**U.S. Army Corps  
of Engineers**  
Engineering and Support  
Center, Huntsville

## **Iron Horse PFF**

### **Building 1925 Fort Carson, CO**

**POTR – Phase 1  
Project No 71165**

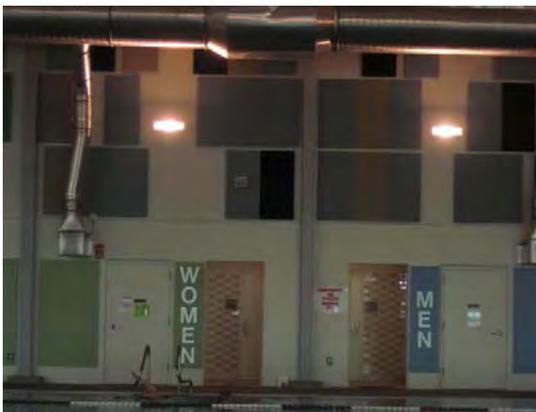
- The doors from the 2 hot tubs swing out into pool deck. This is a safety hazard. They should be set back or swing inward. They are shown in the picture below adjacent to the signs.

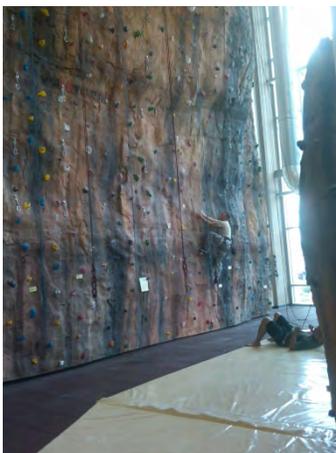
- As seen in picture above, lights underneath jogging track are suspended on chains. This makes them susceptible to damage from balls. Need to require lights under jogging track be surface mounted.
- Need to require a ship's ladder at the very least to provide access from one roof area to another.
- A flood test should be performed on the floor to ensure all water runs to drains.

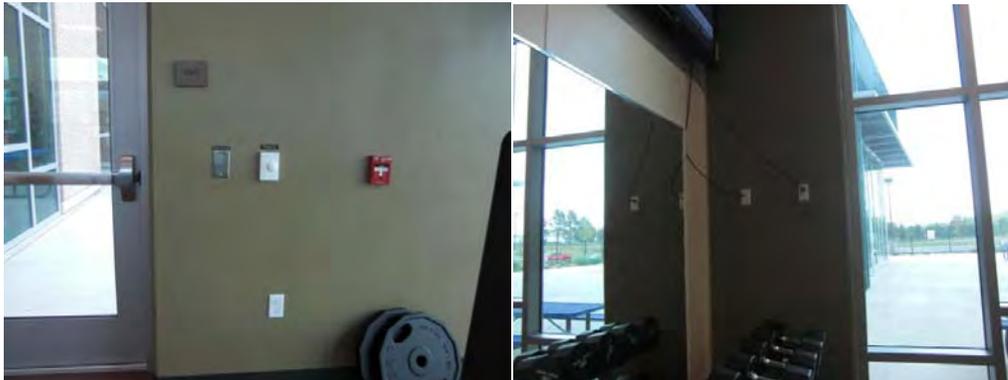
- Document the type of lighting used in the free weight area (minimum 70% indirect). Lights were all direct fixtures
